Project No. 1744-22

October 14, 2024

ADDENDUM No. 1
to the
DRAWINGS AND PROJECT MANUAL
for
TARWATER VETERINARY CLINIC
802 E. CRINER ST.
GRANDVIEW, TEXAS

SA02
A102

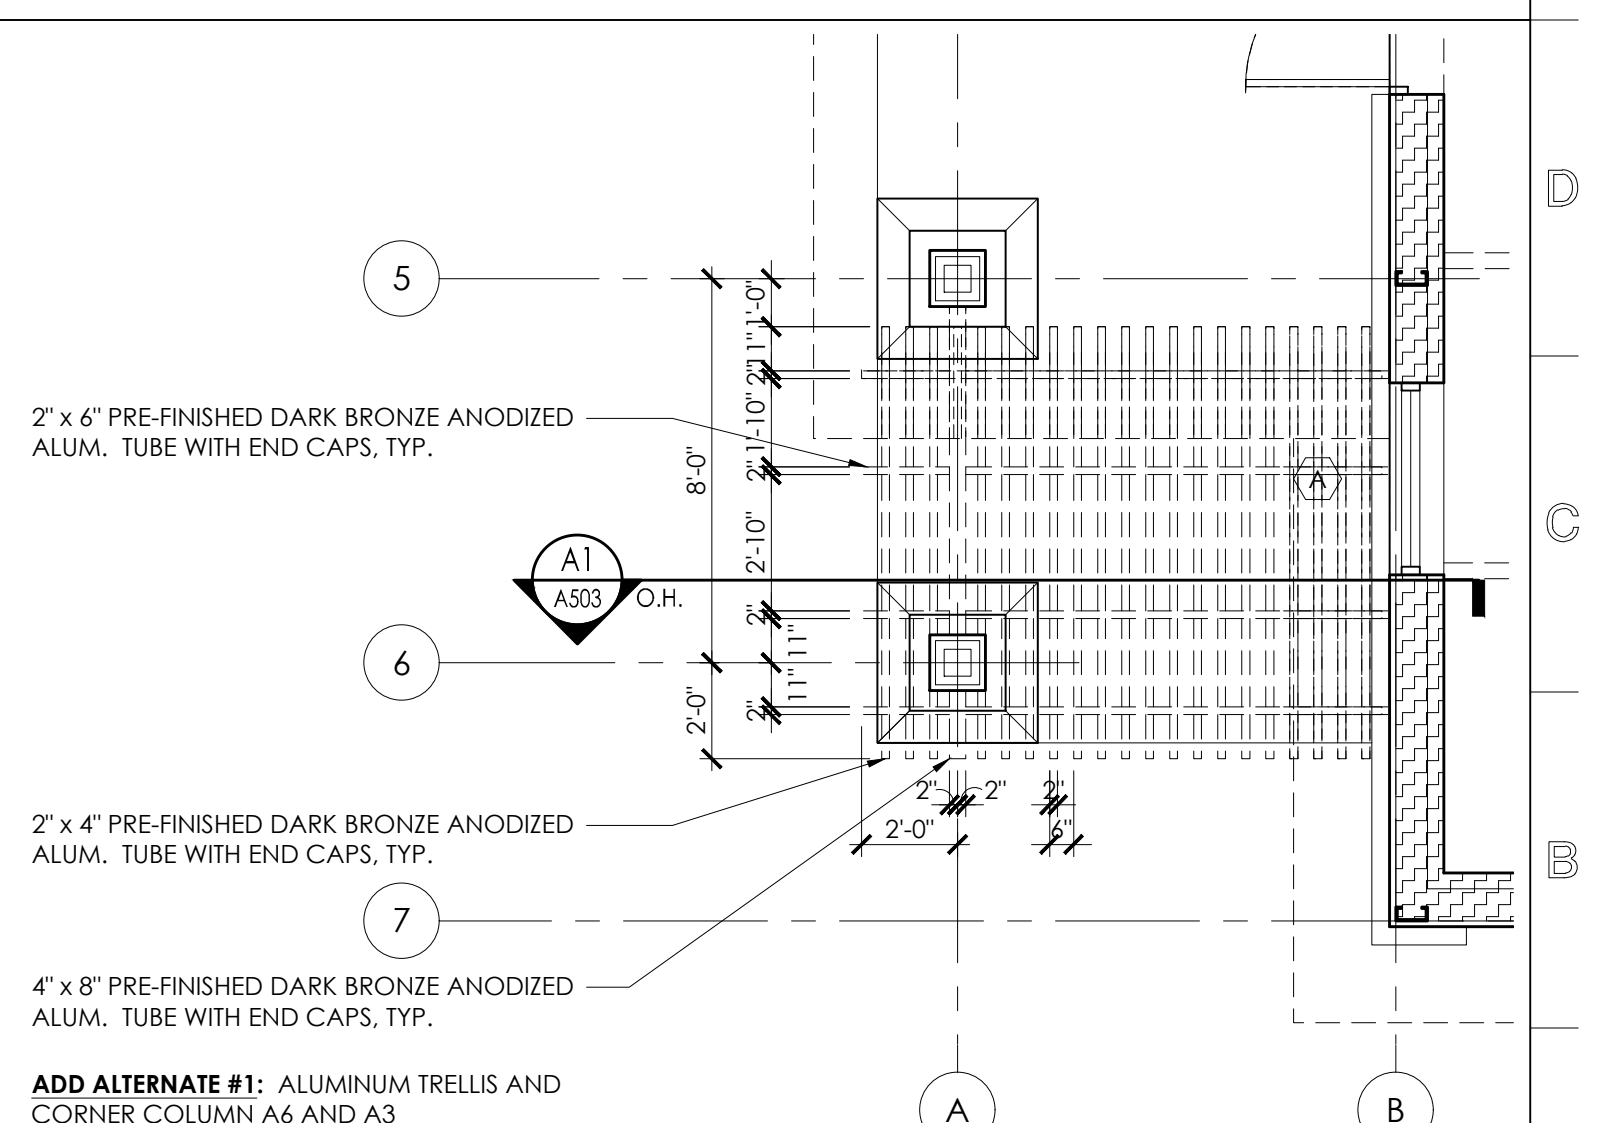
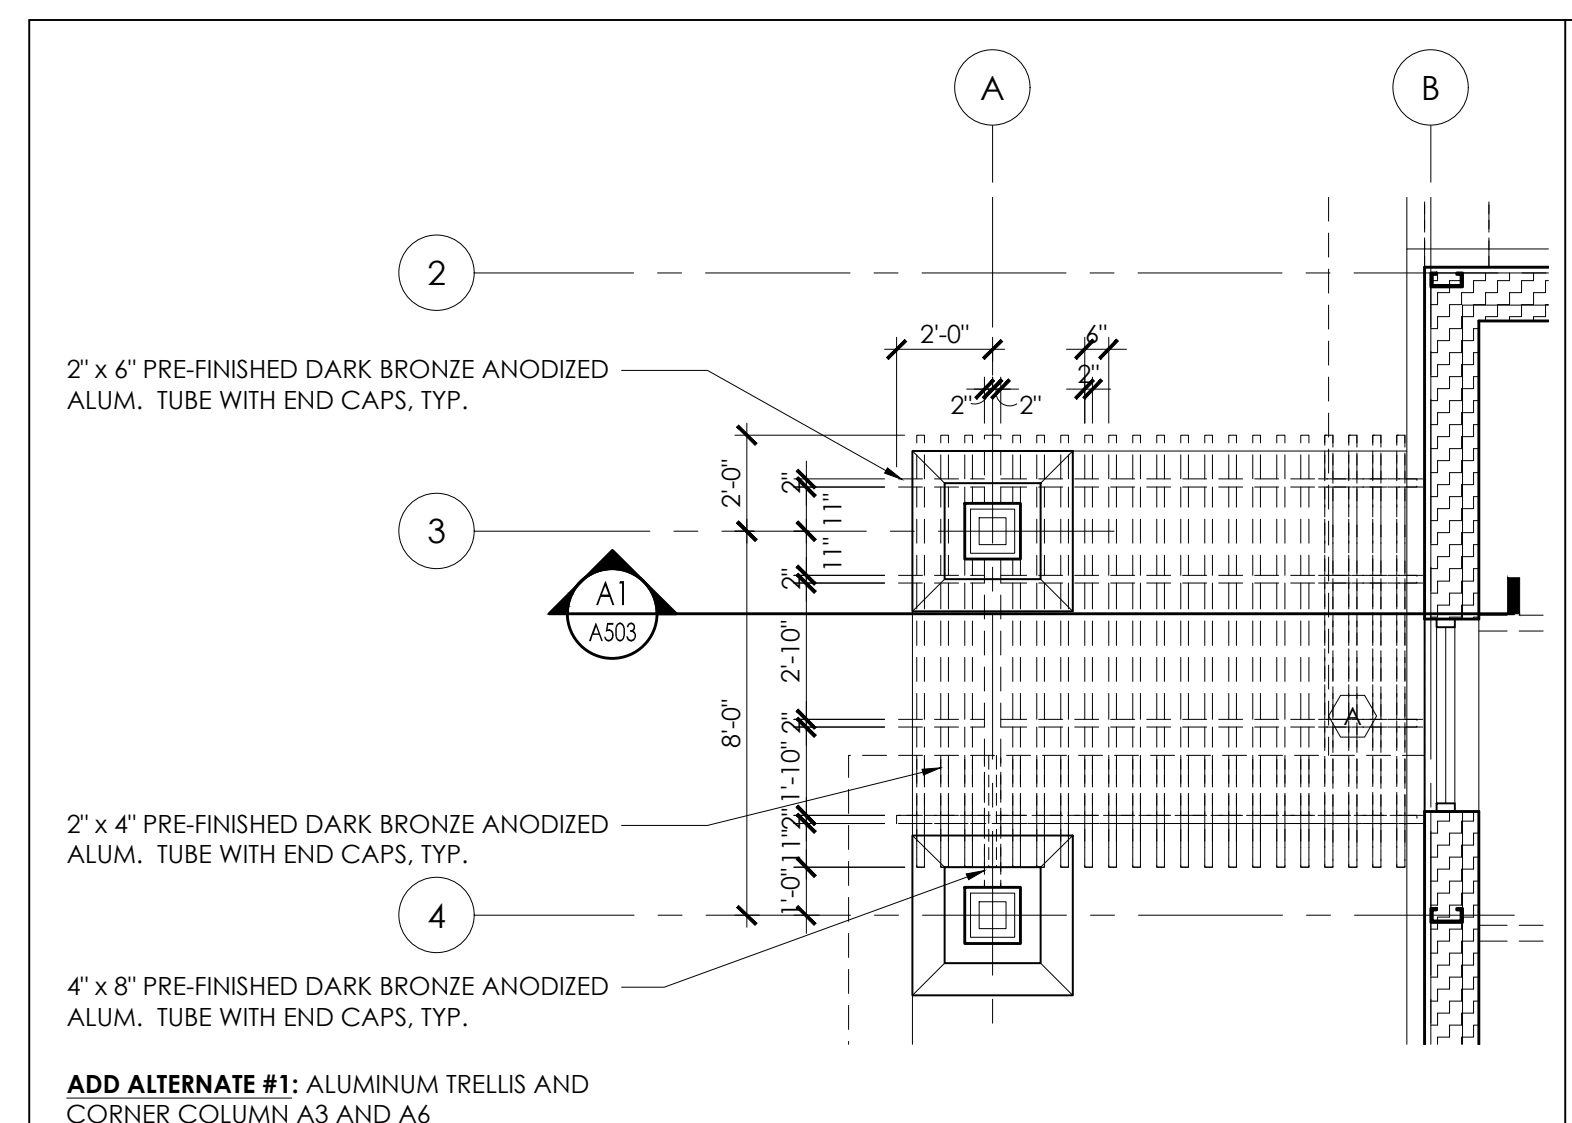
A. Delete this sheet in its entirety & replace with the Revised Sheet SA02-A102 as attached.

- GENERAL ROOF NOTES:**
1. INSTALL ROOF AND ROOF PENETRATIONS ACCORDING TO SMACNA, GOVERNING CODES, AND ROOF MANUFACTURER'S RECOMMENDATIONS
 2. ROOF INSULATION SHALL BE R38 MINIMUM CONSISTING OF 2 LAYERS OF 4" THICK R19 WITH THERMAL SPACER BLOCKS. LOWER LAYER TO BE FACED INSULATION WITH STEEL BANDING FOR SUPPORT.
